ADDENDUM 01 - COVER SHEET

COKE BUILDING / WAREHOUSE FIRE SPRINKLER SYSTEM

PROJECT #4850-02-26

ADDENDUM 01 ISSUED: 07/07/2026

MEZZANINE FLOOR PLAN
SCALE: AS NOTED
SANFORD, *Coca-Cola* BOTTLING COMPANY
SANFORD, NORTH CAROLINA

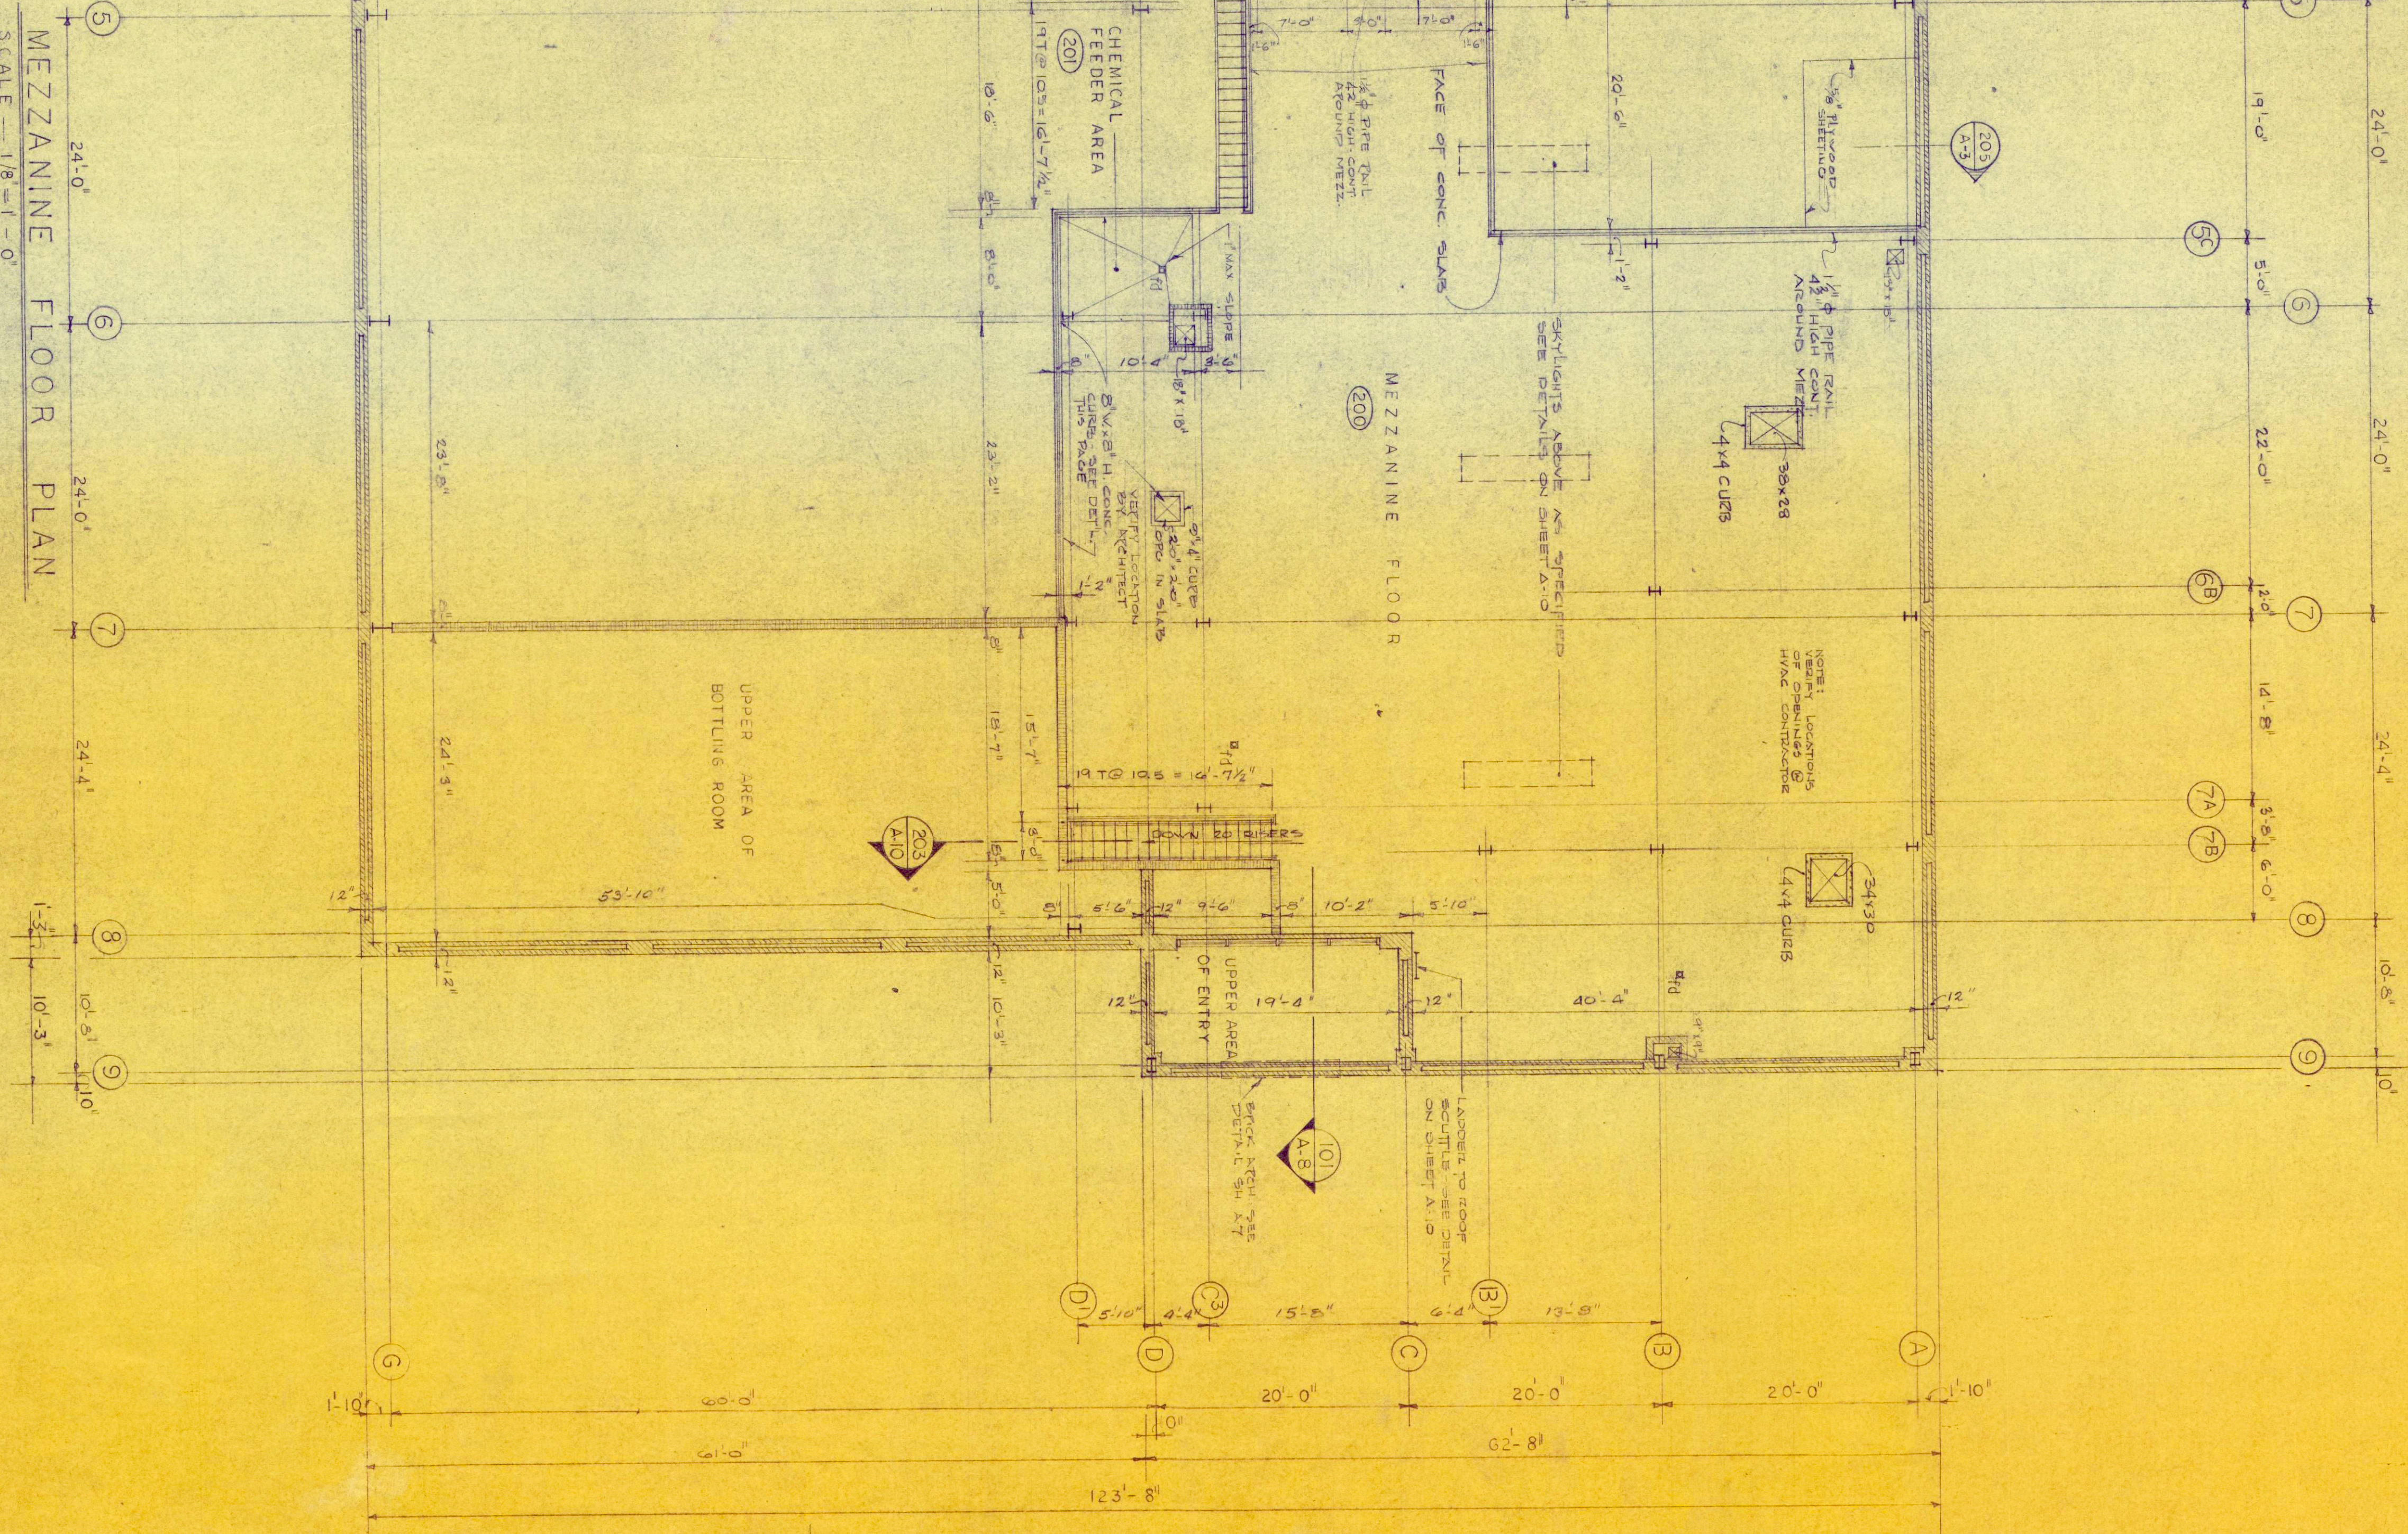
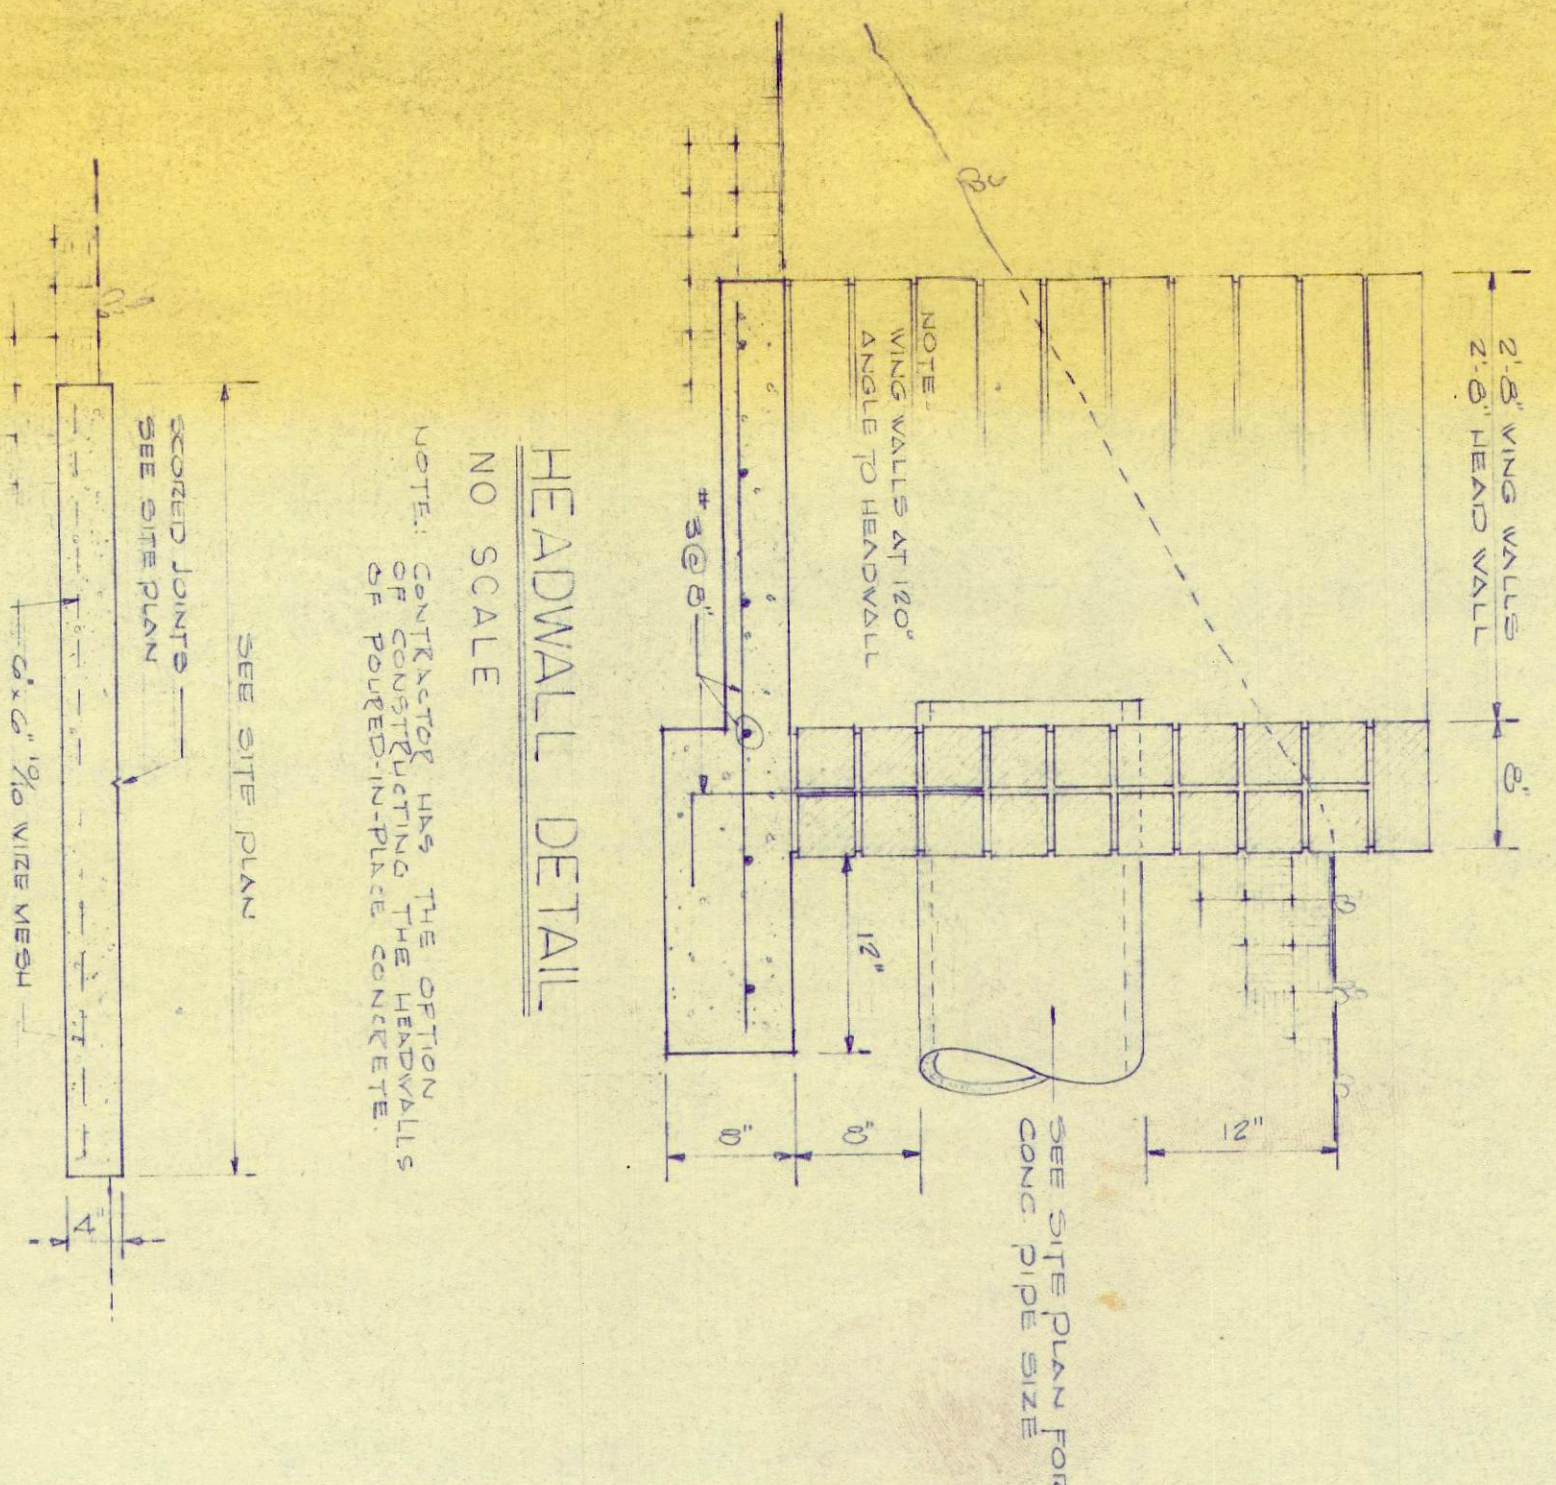
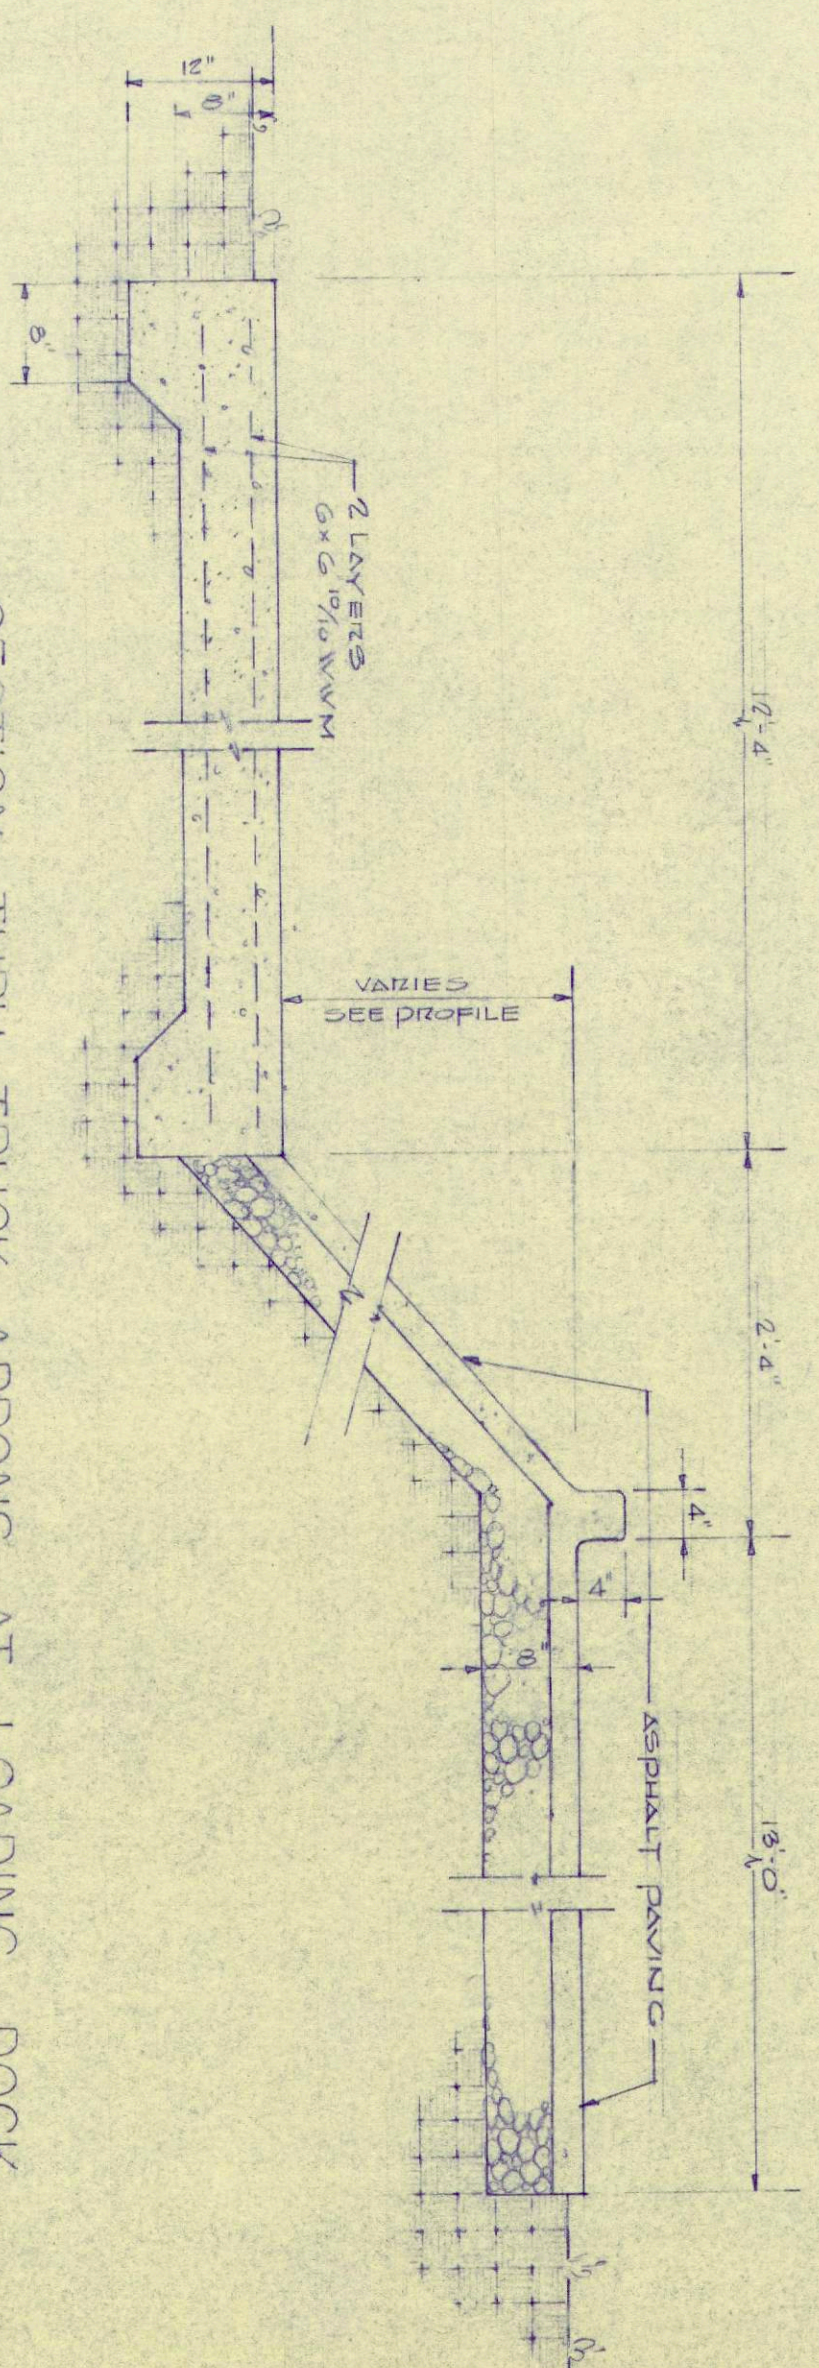
2. Mezzanine Drawing?

ANSWER: See attached drawing (A-3 Mezzanine Floor Plan) for mezzanine level
